SAFETY RECALL NOTICE – Carrier GenV EM-1 Evaporator Unit, component used on certain Ford E-350 Conversions manufactured by The Braun Corporation (Model years 2005-2011)

Vehicle Identification Number: XXXXXXXXXXXXXXXXXXXX
NHTSA Recall Identification Number: 11V131

TAC-SER11-001
01-31-11

Subject: EM1 Gen V Evaporator Units

Serial Number Tag

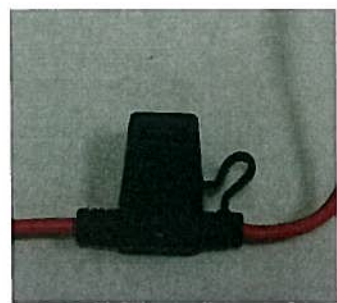
- 2) Once the cover has been removed, the identification tag containing the unit part number, manufacture date, and serial number can be found on the motor "cradle" mount, as seen in the photo below (on left). Compare the information to the above mentioned manufacture date, and/or serial number. Units employing a fuse holder as appears circled in red below require the upgrade with the new fuse holder.

Old Fuse Holder

New Fuse Holder
